NorthConnex Application Number: SSI 13_6136

Please find below my **submission** in response to the exhibition of the EIS for the proposed NorthConnex tunnel project.

Figure 7: Option Preferences from Community Consultation.

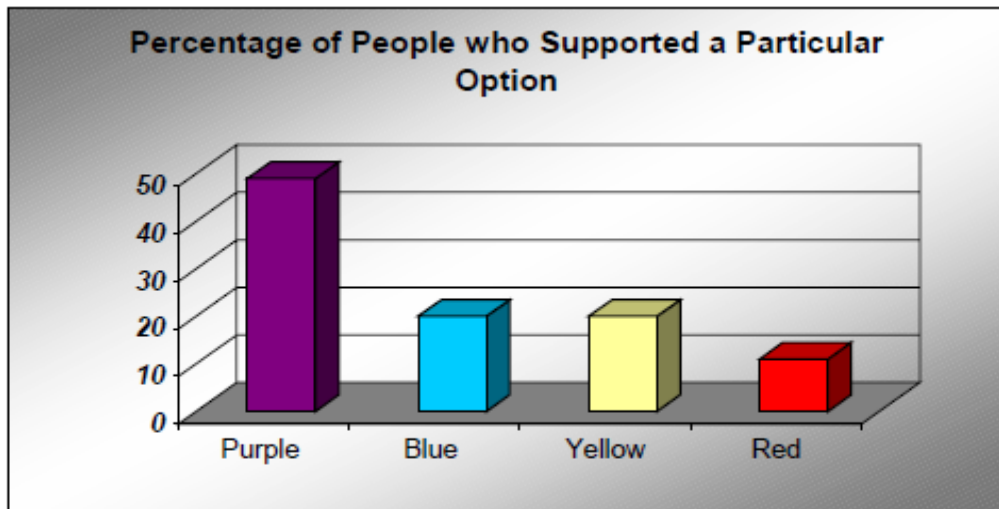
- 2.1. Crucially, the preferred (Purple) option was overwhelming supported by stakeholders in the consultation process (see Figure 7 below). From our

attendance at public meetings and discussions with residents, **this remains the preferred option, with an extension of the tunnel to the north.**
